TREE BOARD
Wednesday, August 19, 2020
2:00 PM
Virtual Meeting

TO: Tree Board
FROM: Mike Gies, Parks and Forestry Superintendent
DATE: August 19, 2020
SUBJECT: Farmdale Estates Landscape and Tree Plan

TO: Tree Board
FROM: Mike Gies, Parks and Forestry Superintendent
DATE: August 19, 2020
SUBJECT: The Residence at Foxtown

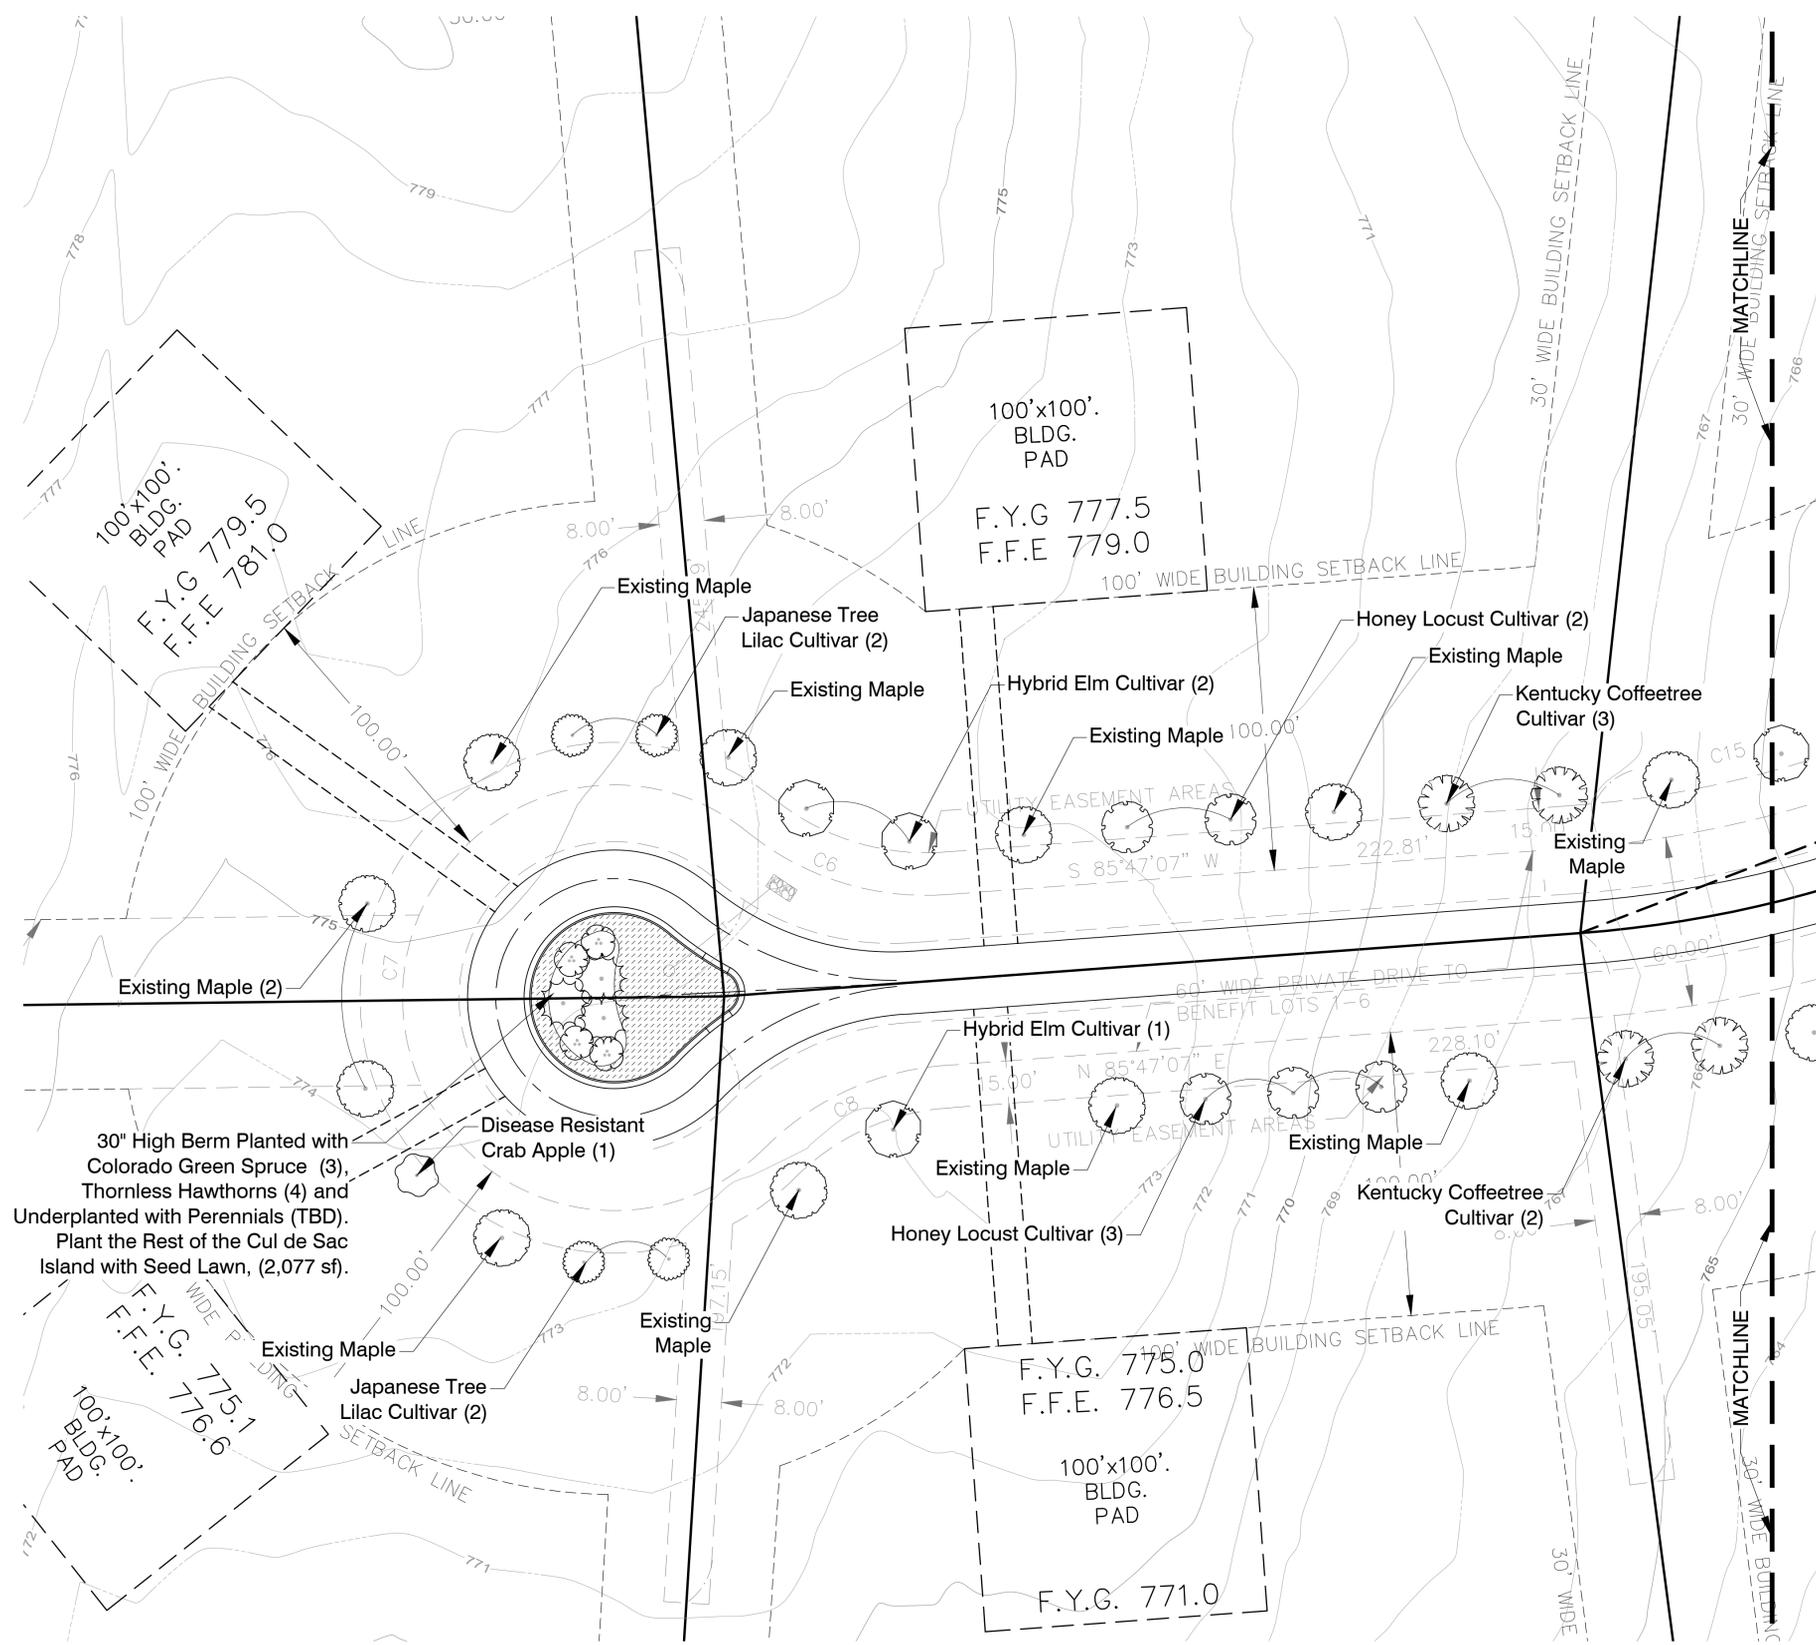
The plan submitted by John Graham, does meet all the general requirements for spacing and quantity as outlined by the City of Mequon's tree planting policy. Suggestions for amendments include:

1. (19) or approximately 33% Maple is a higher percentage of one species of tree than typically allowed. Only 30% of one species is allowed, this means only (17) Maple are permitted. Alternative tree varieties should be discussed or increased to adjust to an acceptable percentage.
2. Substitute more Honey Locust and Kentucky Coffeetree instead of using River Birch. River Birch tend to get chlorotic in this area and do not have as upright of a growth habit as generally required of street tree plantings.
3. Consider utilization of an evergreen other than Colorado Green Spruce. This would only affect 3 trees in the cul du sac, an alternate should be considered.

Staff recommends approval of Farmdale Estates, street tree plan; provided the conditional list above plus other recommended adjustments are made. The approval is based on the installation of (58) street trees along with **mulching, staking, and watering plan**. The city forester will inspect the nursery stock **prior** to planting and approve the crews handling, planting depths, and mulching practices. Staking will be necessary for all installed trees due to the lack of existing homes and other vegetation that would normally act as a wind block. Also required, is a planting schedule/approximate date for planting. It will be the responsibility of the developer or contracted installer to arrange with the Parks and Forestry Superintendent for inspection.

THE RESIDENCE AT FOXTOWN
 LANDSCAPE & STREET LIGHTING PLAN
 DATED: AUGUST 3, 2020

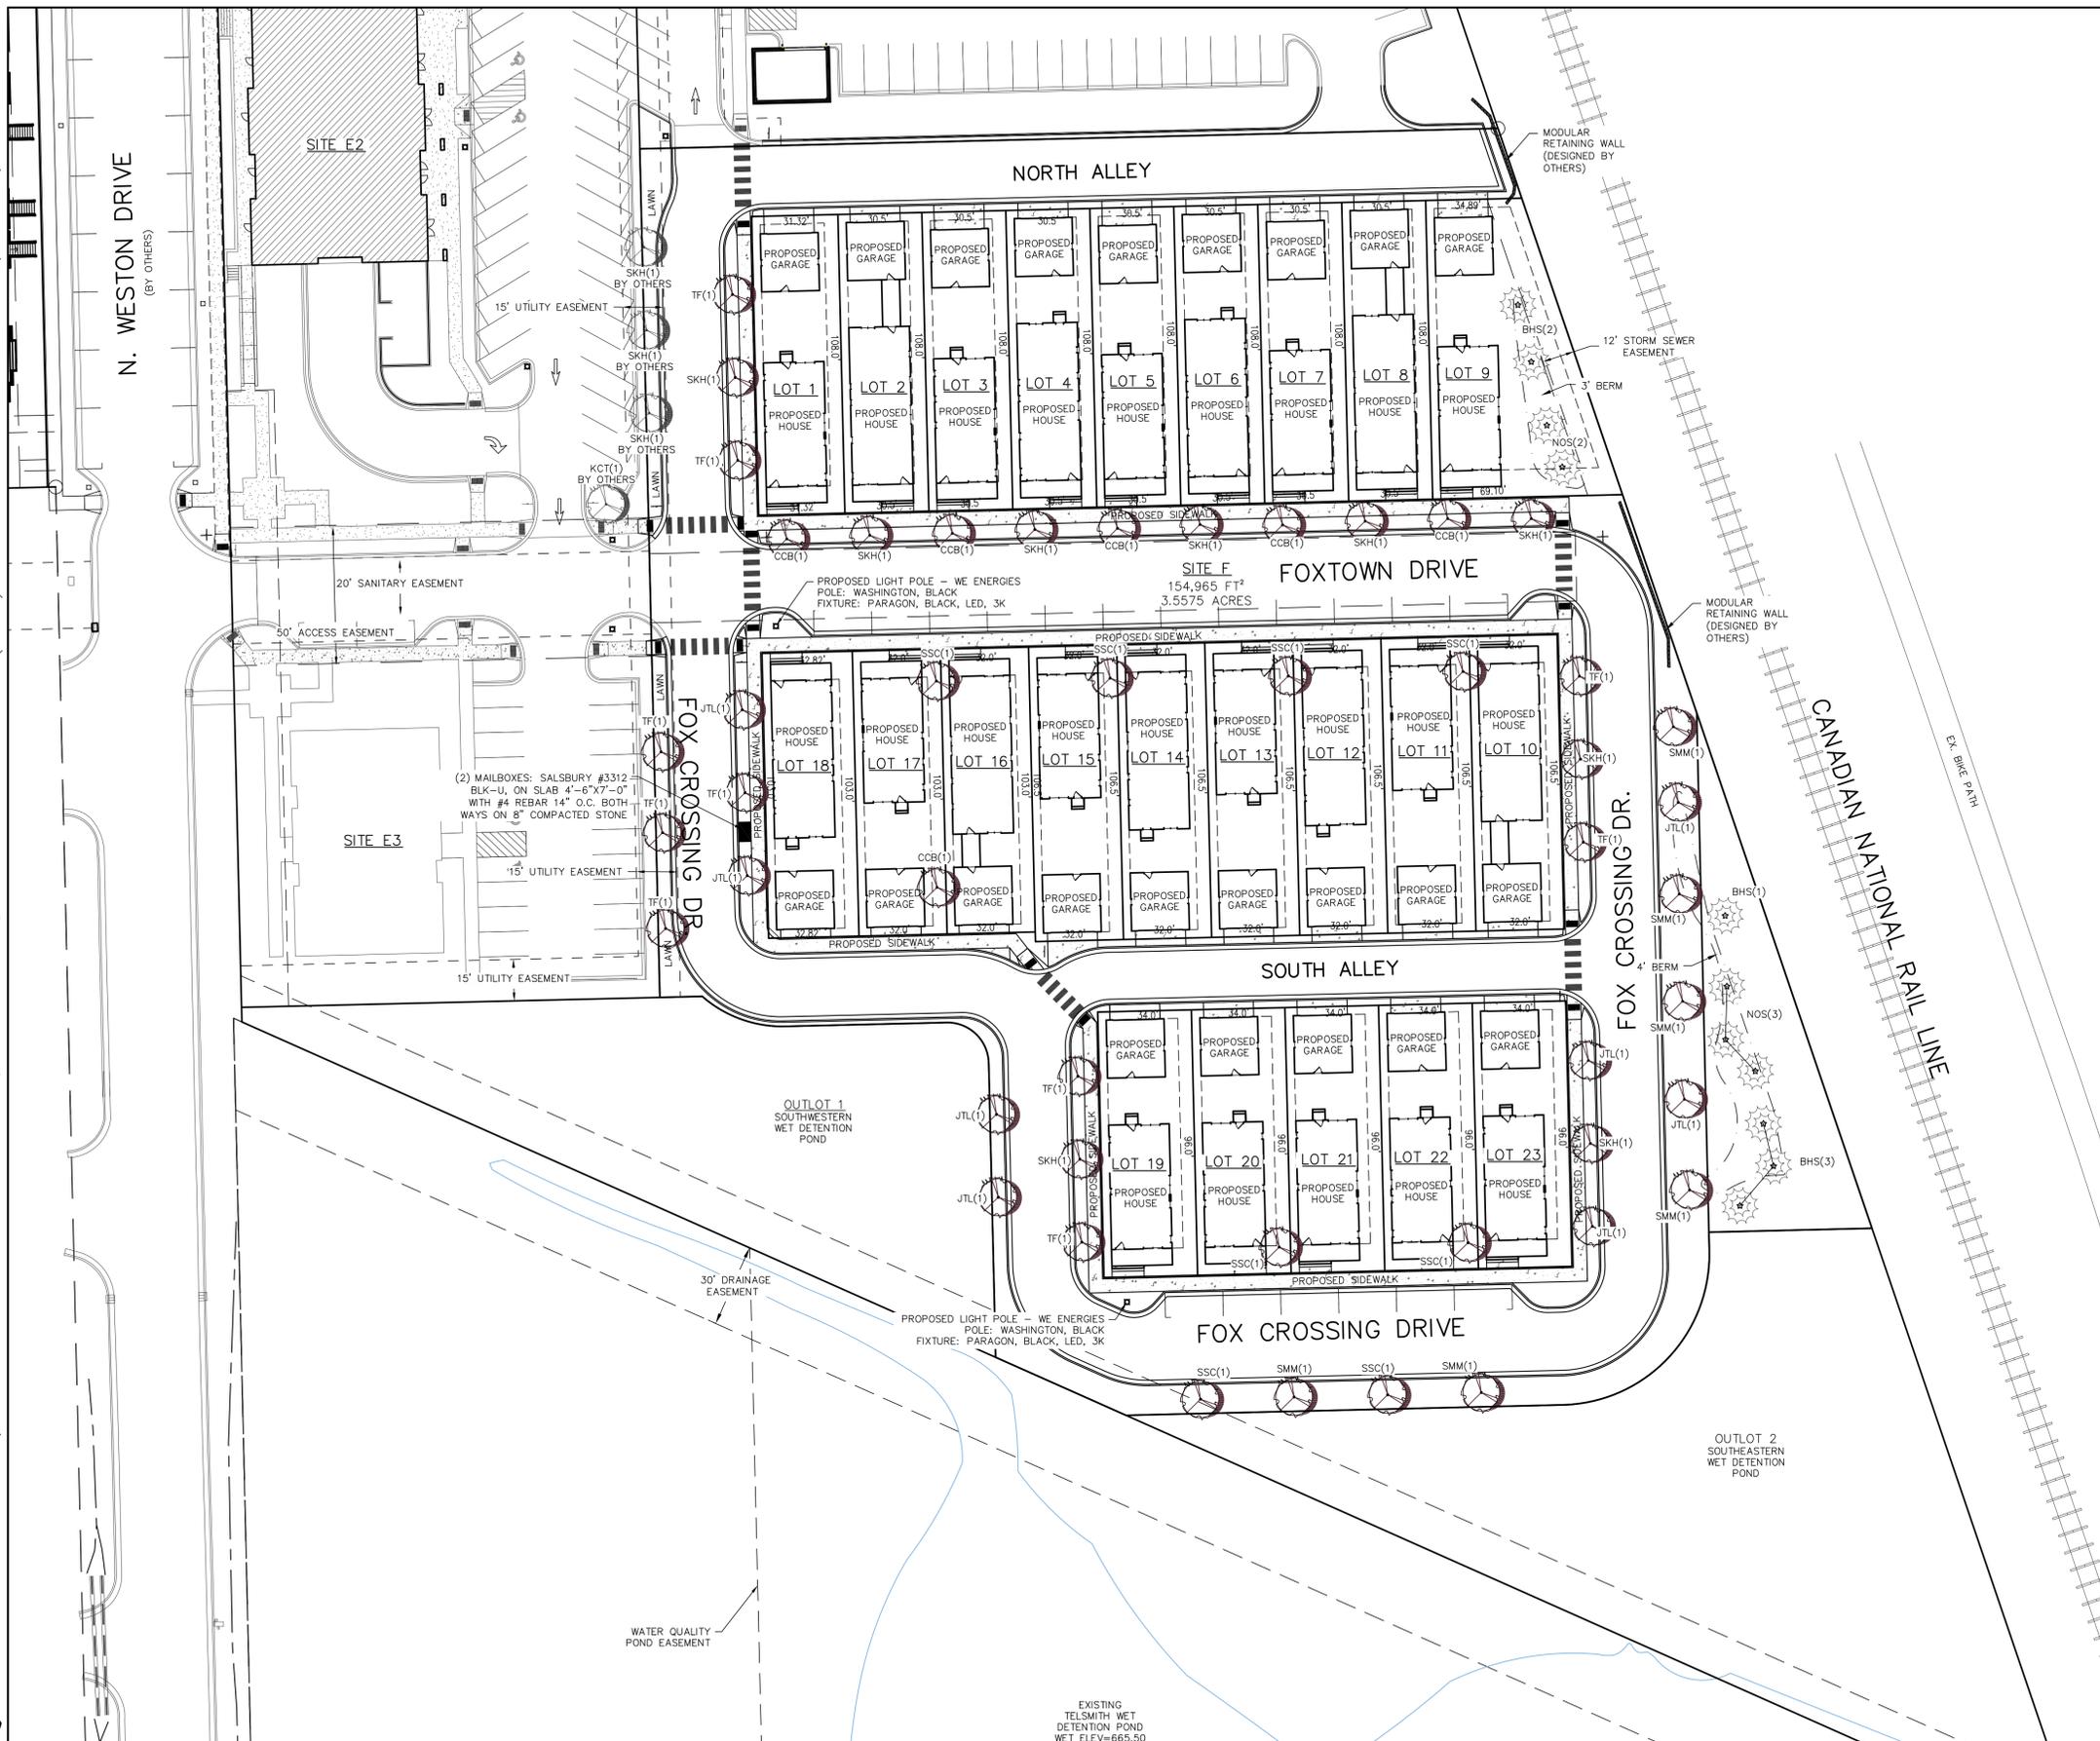
The plan submitted by Brian Scheive, does meet all the general requirements for spacing and quantity as outlined by the City of Mequon’s tree planting policy. Suggestions for amendments would be minimal given the restrictive site.

Staff recommends approval of Foxtown, street tree plan; provided the recommended adjustments are made. The approval is based on the installation of (47) street trees along with **mulching, staking, and watering plan**. The city forester will inspect the nursery stock **prior** to planting and approve the crews handling, planting depths, and mulching practices. Staking will be necessary for all installed trees due to the lack of existing homes and other vegetation that would normally act as a wind block. Also required, is a planting schedule/approximate date for planting. It will be the responsibility of the developer or contracted installer to arrange with the Parks and Forestry Superintendent for inspection.
